Our Ref: J27035
Your Ref: SQ29
Email received 11 May 2012

RE: ESKOM EIA CONCERNS FOR THE PROPOSED NUCLEAR POWER STATION AND ASSOCIATED INFRASTRUCTURE (DEA Ref. No: 12/12/20/944)

Figure 1: Maximum sediment thickness during years 1 to 5 after spoil disposal (extracted from the presentation to the Squid Scientific Working Group by the independent marine consultants)

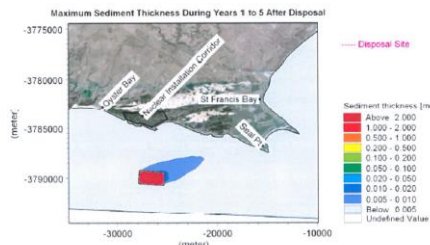
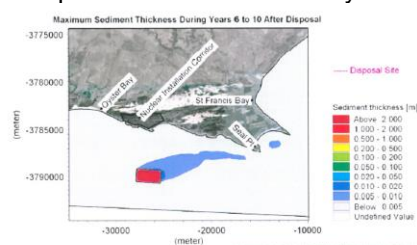
Within the first 5 years following disposal, the sediment is likely to spread to cover an area of approximately 8.3km² with sediment to a mean depth of between 0.5 and 1cm (Figure 1). In the next 5 years the spoil is expected to continue to spread towards Seal Point (Figure 2), eventually covering approximately 0.01km² of the small bay east of Seal Point in sediment 0.5-1cm thick. Sediments will not spread into St Francis Bay.

Your comments reflect the findings of the EIA and are noted.

Figure 3: Maximum suspended sediment concentration near the surface during disposal of the full spoil volume (extracted from the presentation to the Squid Scientific Working Group by the independent marine consultants)

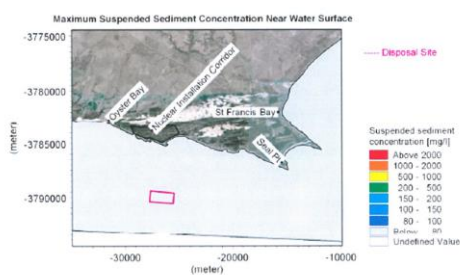
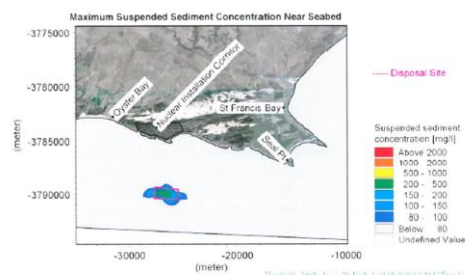
Maximum suspended sediment concentration is not expected to exceed 80mg/l near the sea surface at any time during or after disposal (Figure 3), and will be confined to an area of less than 1.4km² near the seafloor (Figure 4). Turbidity levels of this magnitude will also be temporarily limited outside the disposal site, occurring for a maximum of 2 days throughout the entire disposal period.

Figure 5: Mean temperature increase arising from the release of warmed cooling water from a nearshore piped outlet (extracted from the presentation to the Squid Scientific Working Group by the independent marine consultants)

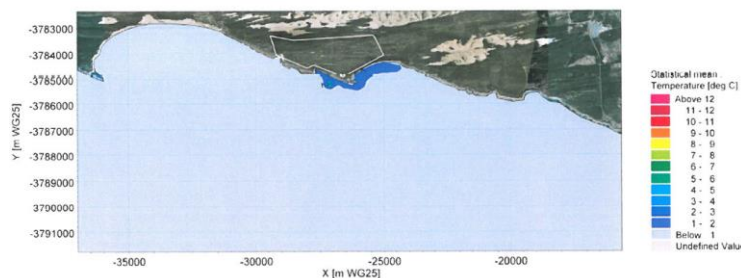
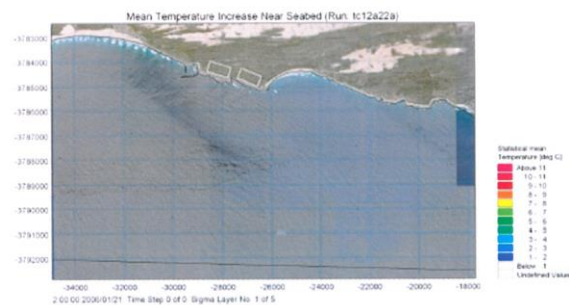
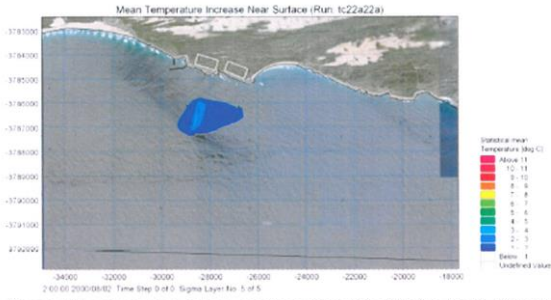
The oceanographic models used to estimate the extent of warm-water release assumed a background (ambient) temperature of 19°C. Release of warmed cooling water will occur from multiple points above the seafloor to maximise mixing with cool surrounding water. A nearshore outflow will result in a mean increase of 3°C near the seafloor, limited in spatial extent to an area of roughly 0.2km² around the outflow (Figure 5). An area of 0.7km² will experience a maximum increase of 3°C or more at any time. Such temperature increases are predicted to be limited to depths shallower than 15m. Offshore release will result in to no temperature increase at the seafloor (Figure 6), while a mean increase of 3°C will affect an area of less than 2.5km² near the surface (Figure 7). Note that the offshore estimates were obtained assuming a 10 000-MW plant (i.e a plant more than double the size of the proposed Nuclear 1 plant). It is likely that the temperature effects of the proposed 4000-MW plant will be less than those described above.

Assessment: Squid will be impacted by the release of warmed cooling water. In the case of a nearshore outflow, adult squid are expected to avoid an area of about 0.2km², and a certain amount of egg mortality is to be expected. This area is, however, less than 1% of the coastal spawning area. In the case of an offshore flow, the impact will be marginally reduced (although the water column will experience elevated temperatures, the seafloor will not). It is likely that adults avoiding the warm-water plume will move to another spawning ground.

Your comments reflect the findings of the EIA and are noted.

Figure 8: Average squid catches per fishing block (expressed as a proportion of the total catch) and squid fishing vessel presence (computed from VMS data) over the period 2006 - 2011

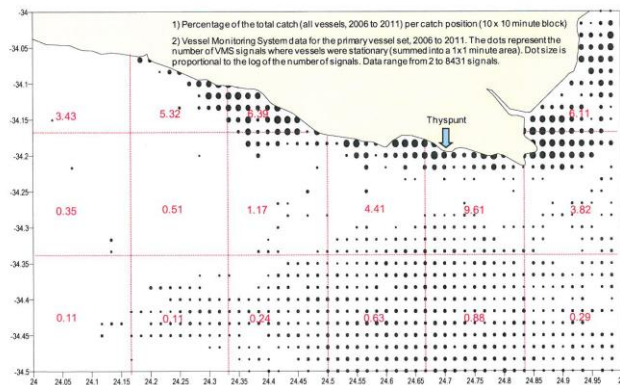
The fishing block immediately adjacent to the Thyspunt site yields on average 9.61% of the total squid catch (Figure 8). Vessel Monitoring System (VMS) data indicate that squid vessels spend most of their stationary time (presumably the time spent fishing) relatively close to the coast (Figure 8). The average catches calculated for each fishing block may therefore not reflect an accurate perception of the potential impacts of the Nuclear 1 development on the squid fishery in terms of lost catch.

The squid fishing industry (SASMIA) is advised to collect the required high-resolution information on spatial distribution of catches, which would enable it to provide a more accurate assessment on the magnitude of the catches that may be impacted by Nuclear 1.

Your comment is noted and will be forwarded to SASMIA.

Figure 9: The 6 “paralarvae” release zones and the “mortality” zones used during the IBM model of paralarval transport.

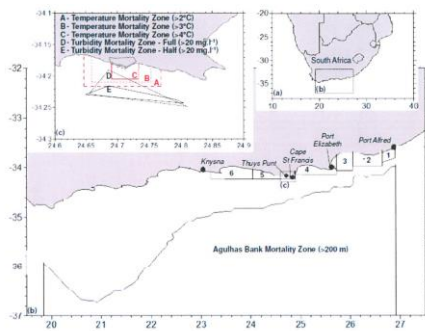
- Plumes of elevated turbidity (>20mg/l) resulting from disposal of either the full spoil volume (mortality zone D in Figure 9) or half of the spoil volume (mortality zone E in Figure 9).
- Plumes of water temperature that were on average 2°C (mortality zone A in Figure 9), 3°C (zone B) or 4°C (zone C) warmer.

Within the model, “paralarvae” were released from 6 release zones (Figure 9) and their transport was driven by the hydrodynamic model, incorporating diel vertical migration effects.

Paralarvae were considered to have died if advected off the shelf (“Agulhas Bank Mortality Zone” in Figure 9) when older than 4 days (to account for yolk-sac depletion), or if they came into contact with the elevated temperature and turbidity plumes. A number of simulations were run for each scenario in order to measure the variance associated with mortality estimates.

Your comments are noted and reflect the findings of the Nuclear-1 Marine Assessment.

It is recommended to place spoil at a deep site and thereby avoid shallow spawning sites as much as possible. However, the spread of spoil that takes place after disposal will take the sediment into shallower areas and impact on some spawning habitat. This is unavoidable and current-driven. However, the impact of spoil disposal at a deep offshore site would still be much lower than disposal at a shallow site.
